Attachment A: Errata

Lahar Detection System Environmental Assessment

Mount Rainier National Park

March 2022

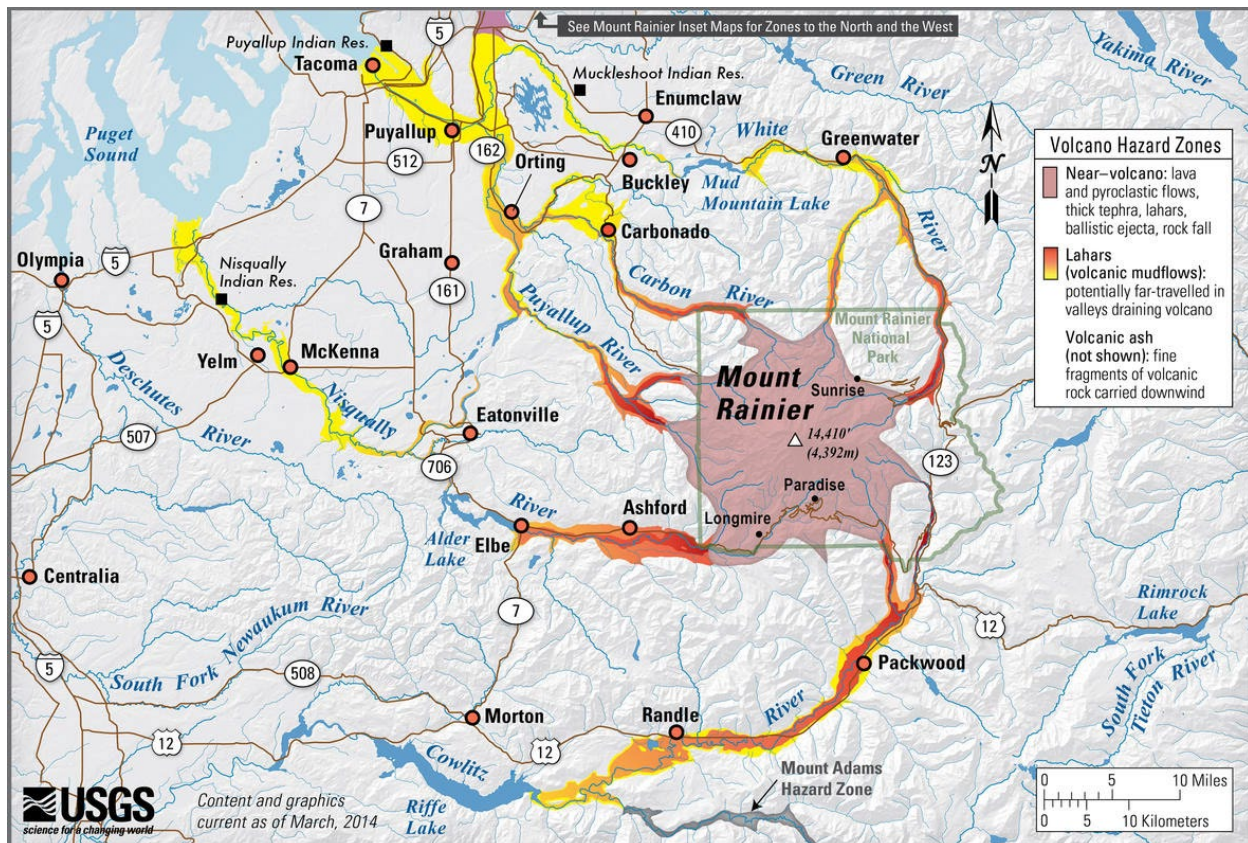
“...The remaining nine stations would be installed to increase rapid detection along the west flank of Mount Rainier, which is the most vulnerable to a large lahar down the Puyallup River, Mowich River, or Tahoma Creek drainage (*Figure 1*).” (*Note that all subsequent figures to be renumbered*).

In addition, add map below on page 6 of the EA, to provide context and geographically reference to the drainages of concern.
